**NEW MEXICO ENVIRONMENT DEPARTMENT  
INSPECTION OF PUBLIC RECORD REQUEST FORM**

1. NMED's technical completeness determination or additional request for information on New Mexico Copper Corporation's discharge permit application, date range June 28, 2017 through July 19, 2017;
2. NMED determination regarding Copper Flat Copper Mine pit lake being a private water, date range June 28, 2017 through June 19, 2017;
3. Bureau of Land Management request to the Surface Water Quality Bureau to write a letter of concurrence for the Surface Water Quality Bureau's benefit regarding the proposed Copper Flat Copper Mine pit lake and associated patented claims surveys completed and a

To: Shelly Lemon, Chief, Surface Water Quality Bureau  
Michelle Hunter, Chief, Ground Water Quality Bureau  
From:  Melissa Y. Mascareñas, Department Public Records Custodian  
Date: September 6, 2017  
Subject: Request to Inspect Public Records

**FIGURE 2-12:**  
Offsite Copper Flat  
Ancillary Facilities

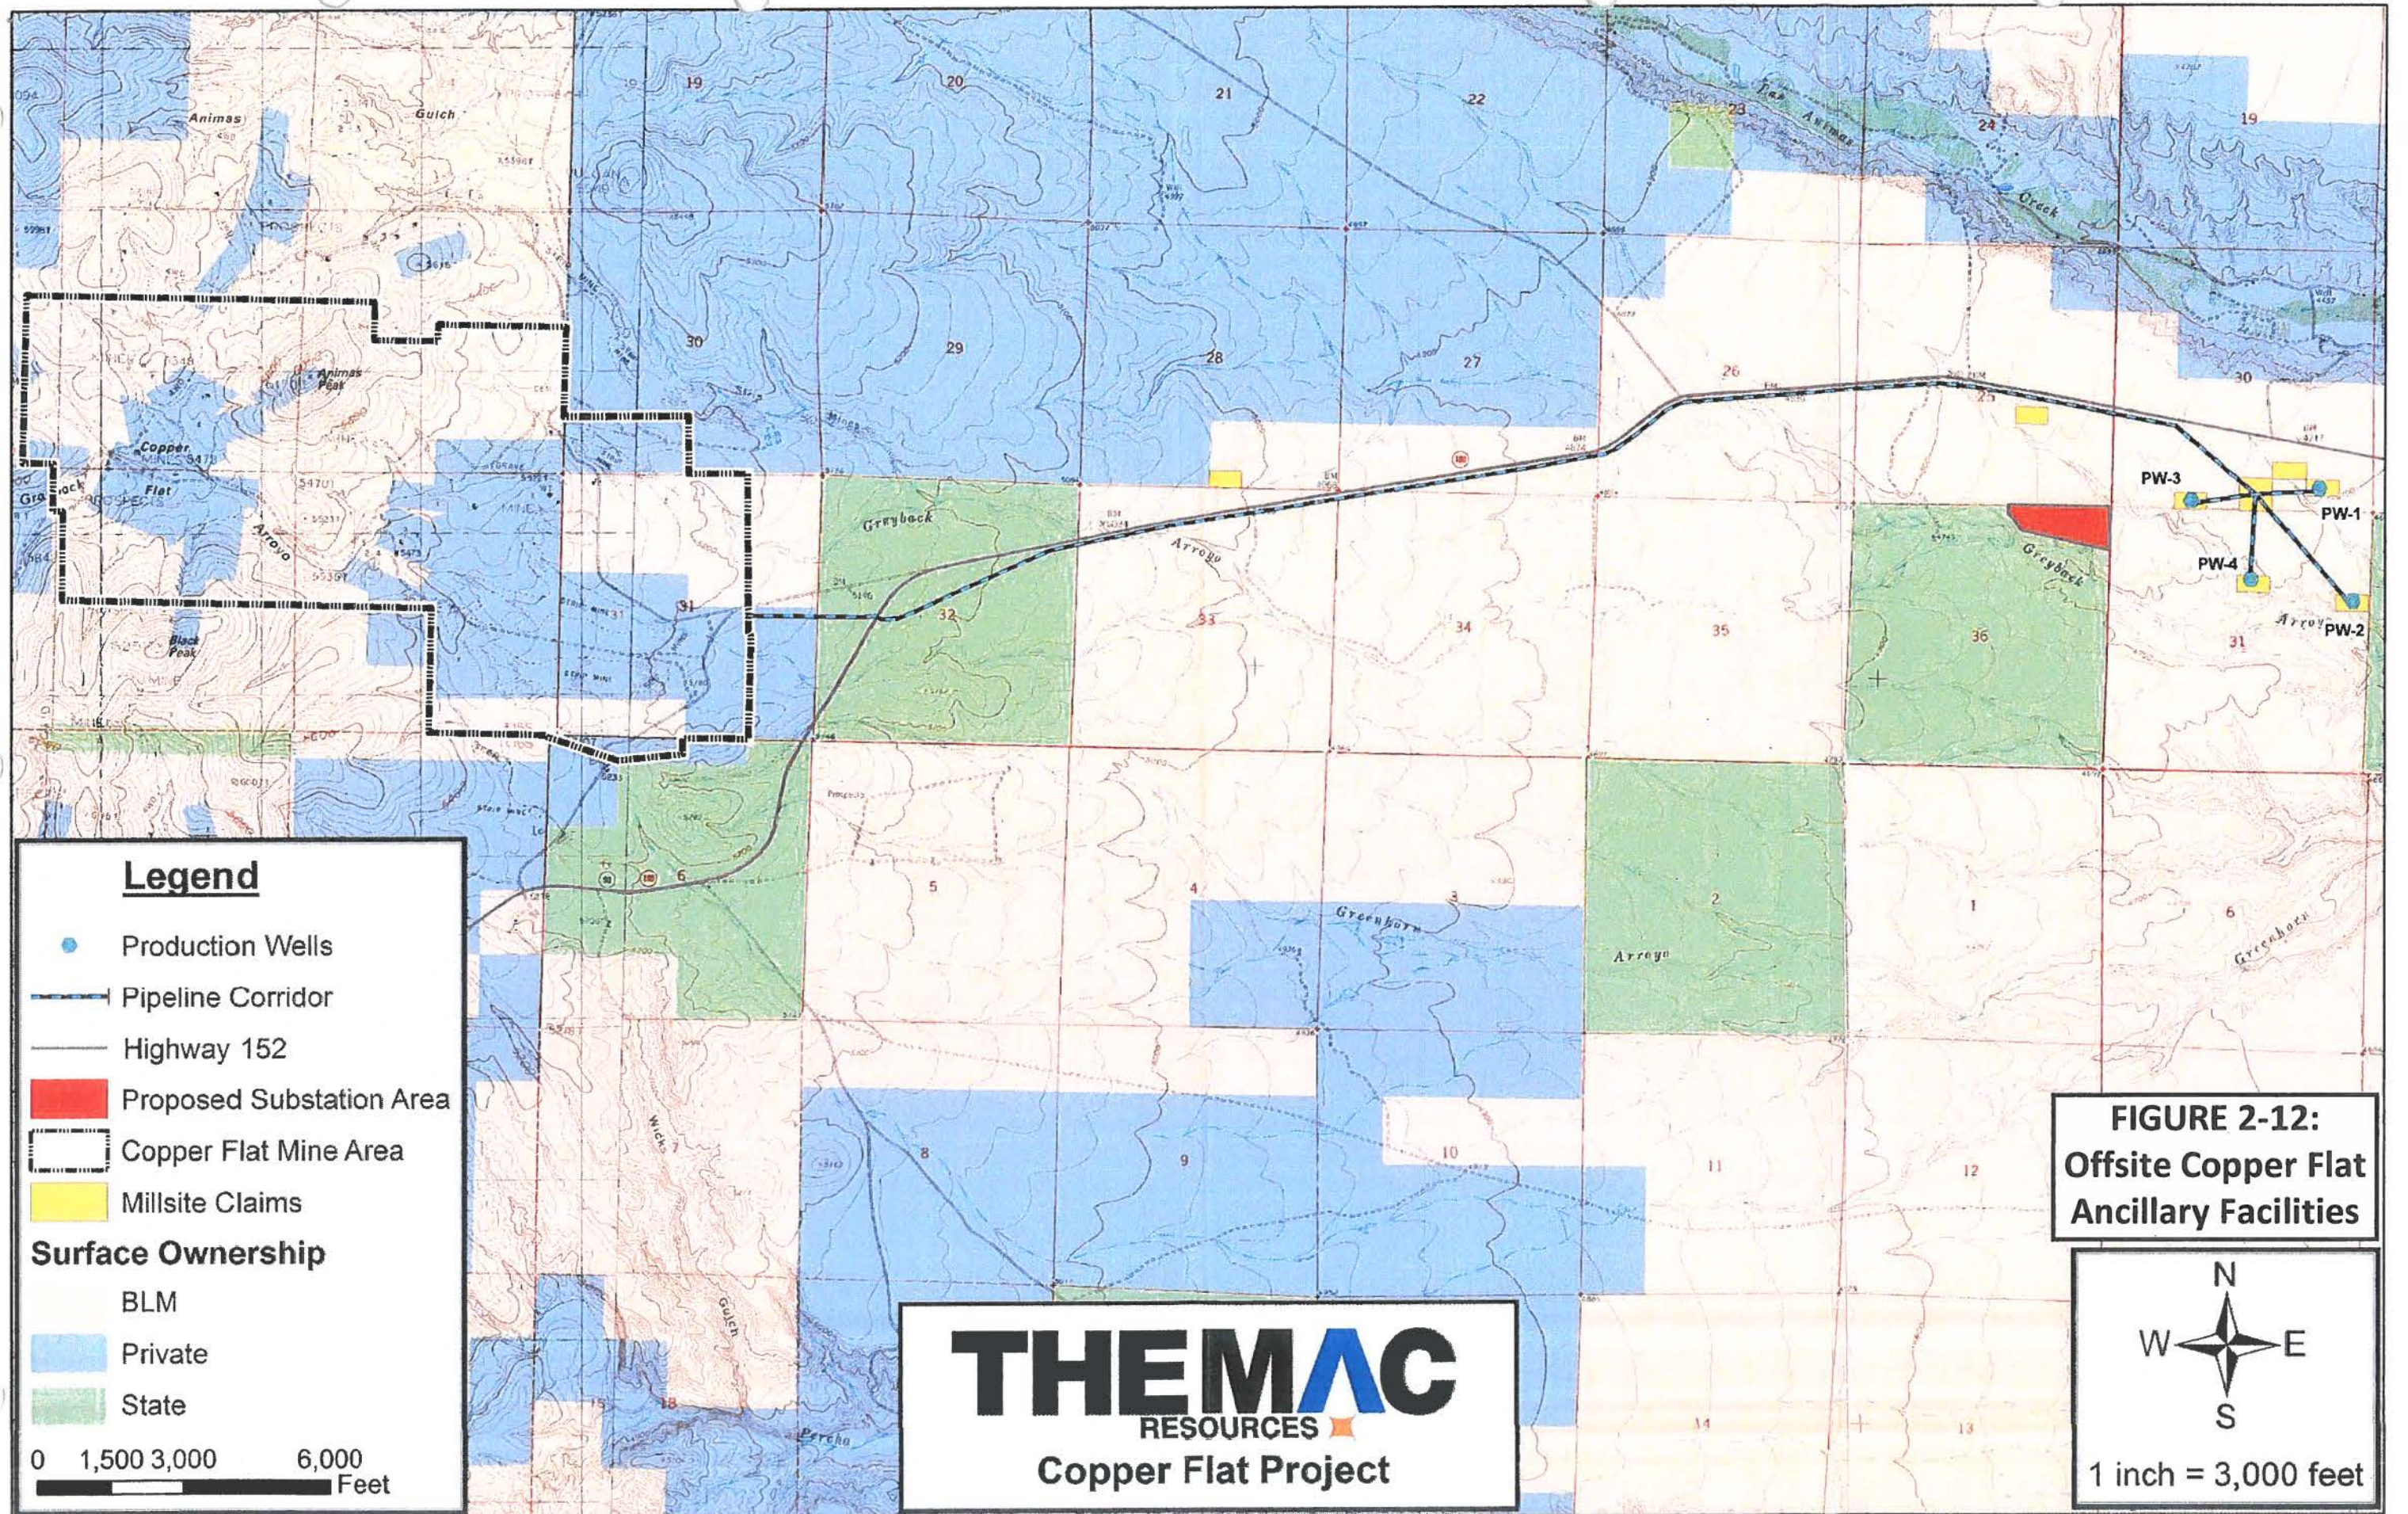
The location of the production well field can be seen in Figure 2-12 of NMCC's Updated MORP, a copy which is attached for your convenience. The well field wells are all completed into the same formation, i.e., the Santa Fe Group, all in the same general location. You may recall that the water quality data was generated as a result of the pump test approved by NMED and conducted by NMCC. In conducting the test, NMCC equipped wells PW-1 and PW-3 for pumping and sampling. The data was provided to NMED in May 2012 and is included in JSAI's memorandum.

Figure 11K-4. Hydrogeologic cross-section PA-PA'. Copper Flat Mine, Sierra County, New Mexico.

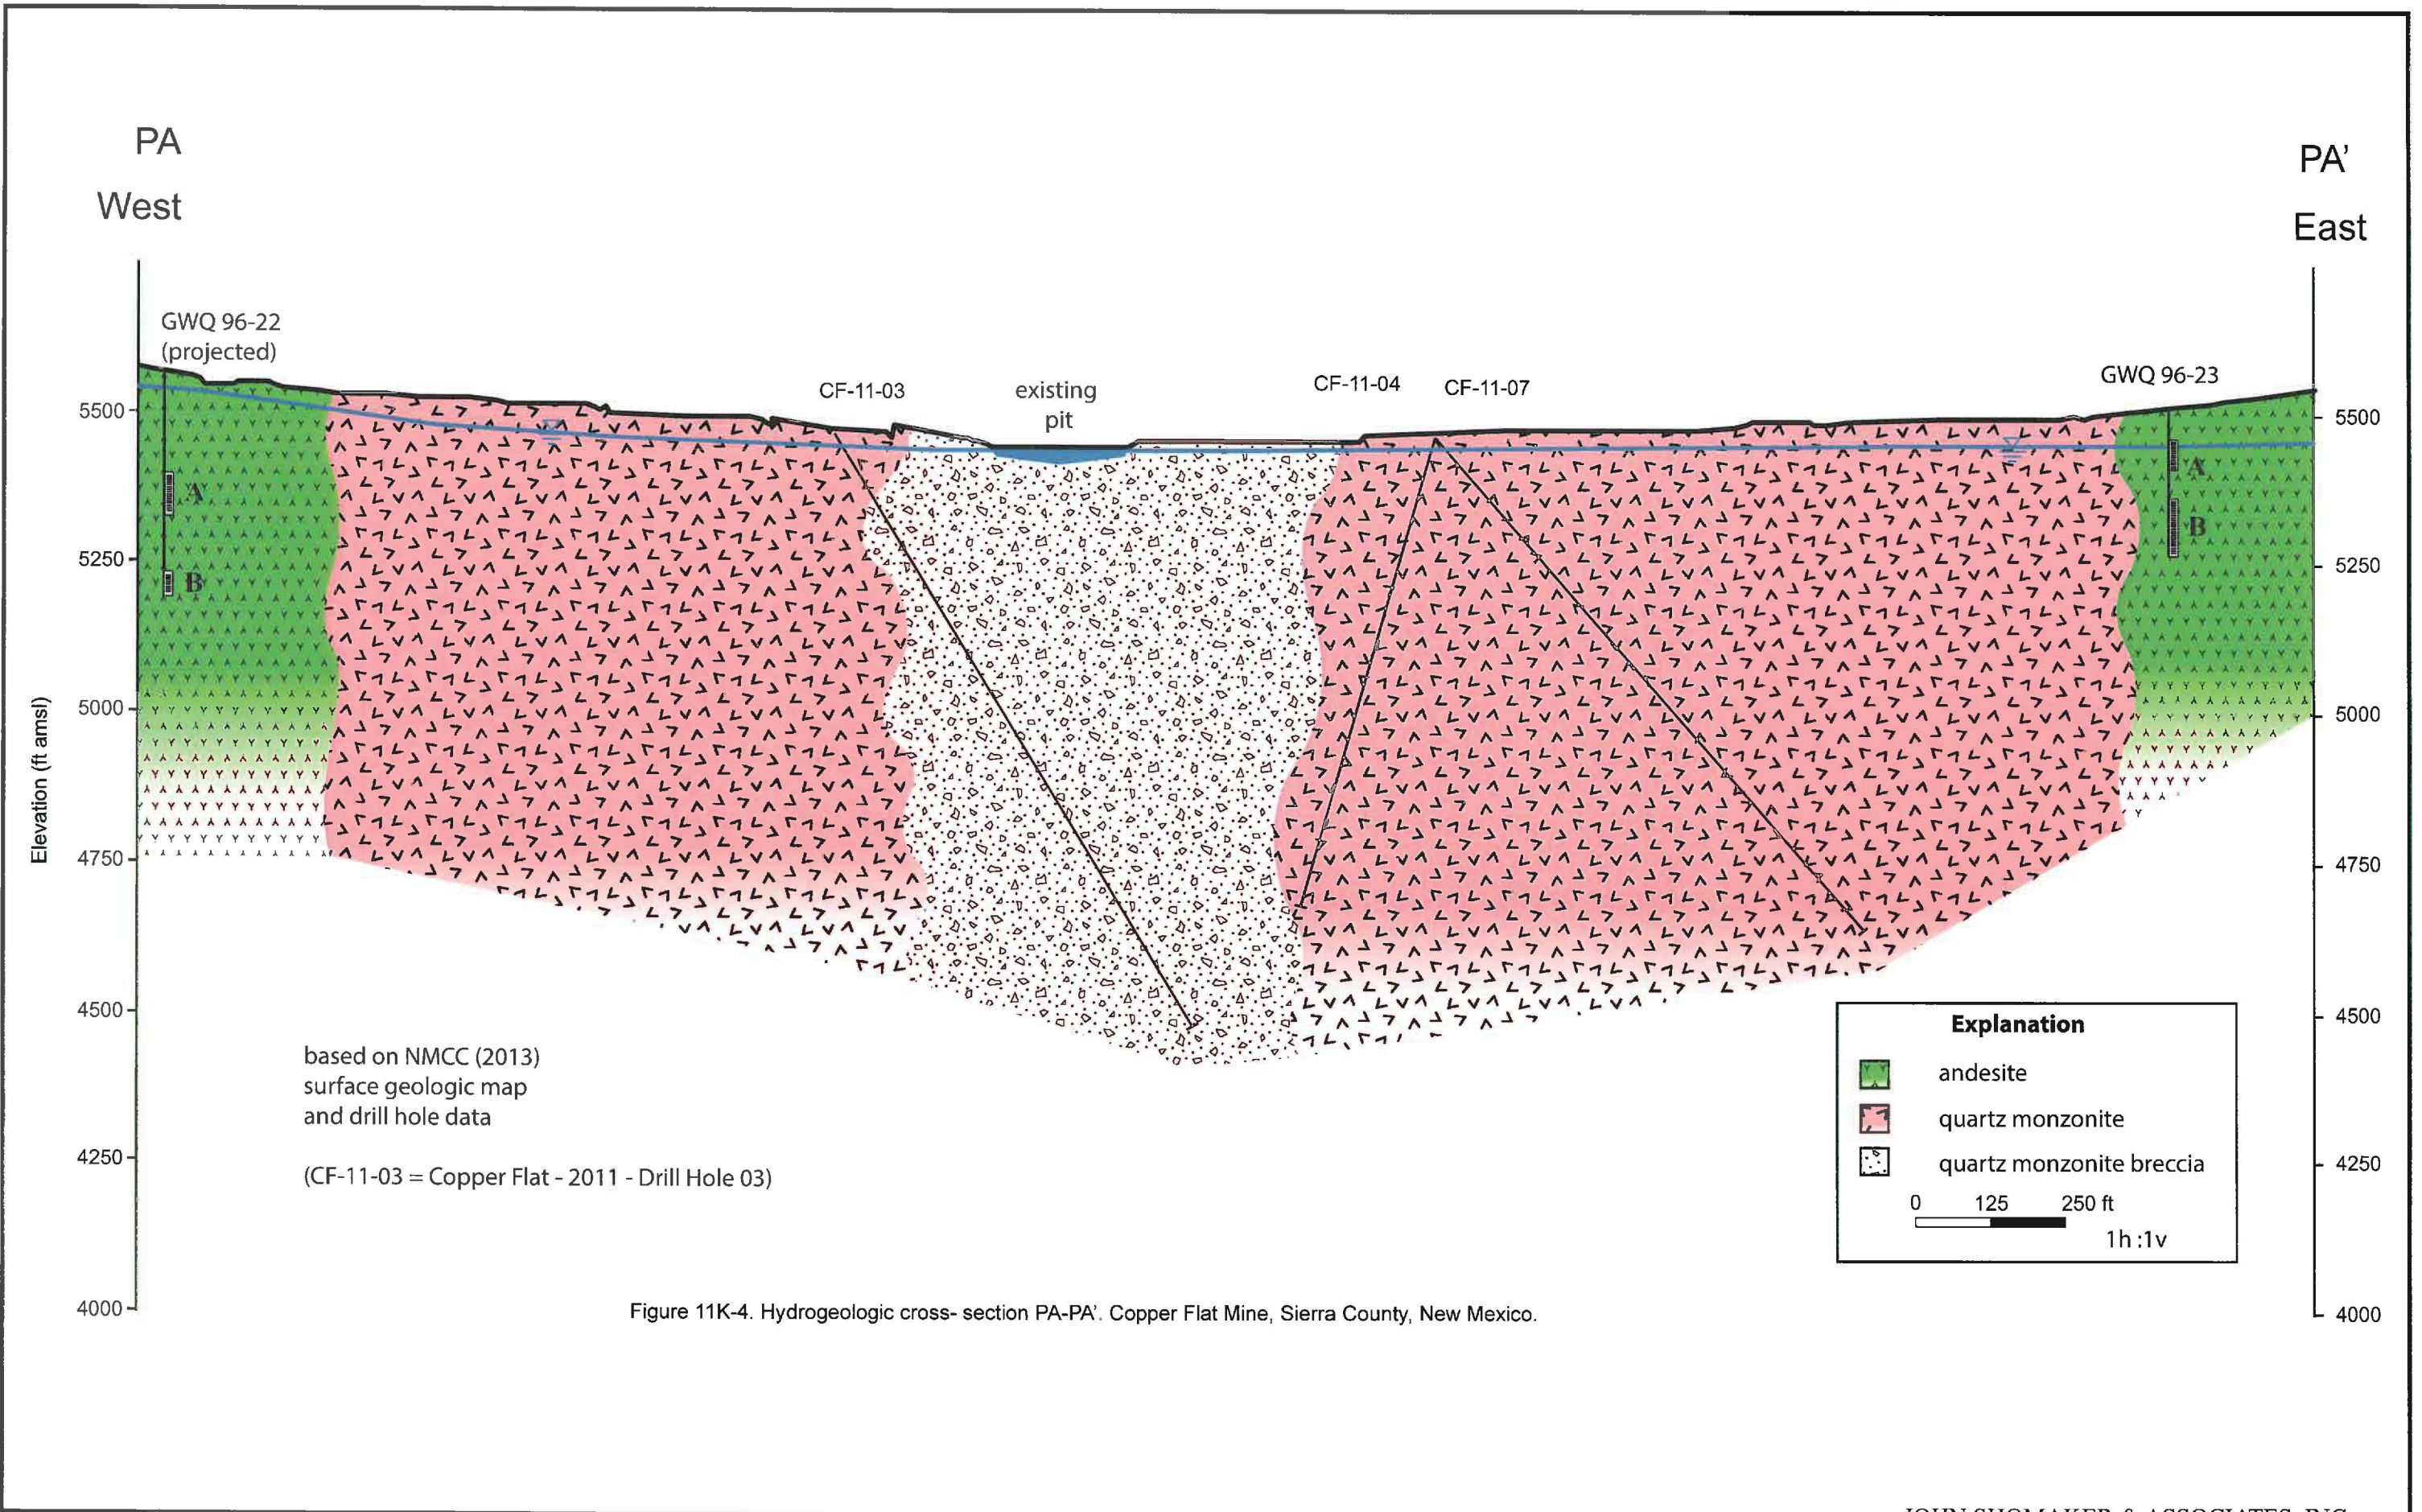
I have also attached a couple of other figures important to explaining how NMCC will meet the 22.A.(1) requirement, Figure 11K-4 Hydrogeologic Cross-Section PA-PA', from the DP Application, Revision 1 (page 114) and a figure titled "Plant Area Geology".

Figure 11K-4, is included to help orient the more detailed plant area figure to Figure 11K-2a. Figure 11K-4 shows the cross-section line of PA-PA' from the western edge of the site beginning approximately at Well GWQ 96-22 in the andesite across the quartz monzonite (i.e., the pit location) to a point to the east past Well GWQ 96-23, also in the andesite formation. It is important to note from the cross-section that the andesite bedrock formation is over 500 ft. thick, continuing to the east under the plant area.
